From: [REDACTED]
Sent: 20/02/2024 8:33:34 AM
To: Council Northernbeaches Mailbox
Cc: Chris Street; Mia
Subject: TRIMMED: DA 2024 0044 25-27 KEVIN AVENUE, AVALON BEACH NSW
2107 WRITTEN SUBMISSION: LETTER OF OBJECTION SUBMISSION:
TULLOCH
Attachments: 25 KEVIN WS.pdf;

SUBMISSION

RE: DA 2024 0044
25-27 KEVIN AVENUE, AVALON BEACH NSW 2107
WRITTEN SUBMISSION: LETTER OF OBJECTION
SUBMISSION: TULLOCH

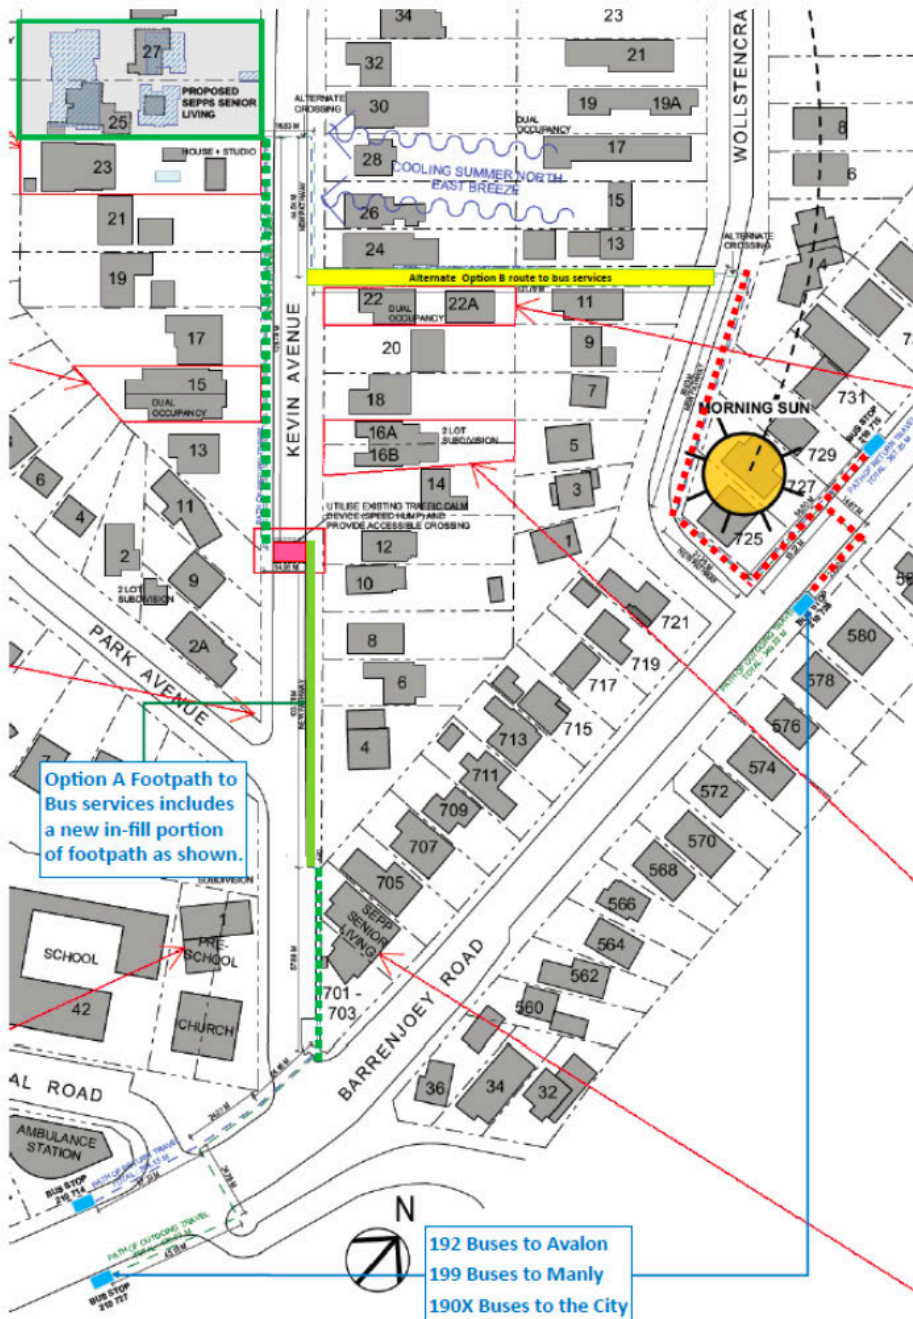
The applicant has not provided adequate survey or design to show how access to the bus stops will be achieved to satisfy this very important clause in the SEPP.

The simple line drawing provided, would appear:

- To be in excess of 400m;
- Transverse land zones that exceed 1:14 in slope;
- The gradient at the end of Kevin Avenue where it meets Barrenjoey Road is significantly steeper than the 1:14 slope specified in SEPP and would not be suitable for wheel chair users, particularly if this was a part of a significant 400m journey for wheel chair users;
- Requires removal of significant trees and landscaping in the Council reserve, including the large native tree between 28 Kevin Avenue & 30 Kevin Avenue;
- Cuts through power pole locations;
- Places pedestrian crossings adjacent to or across existing driveways
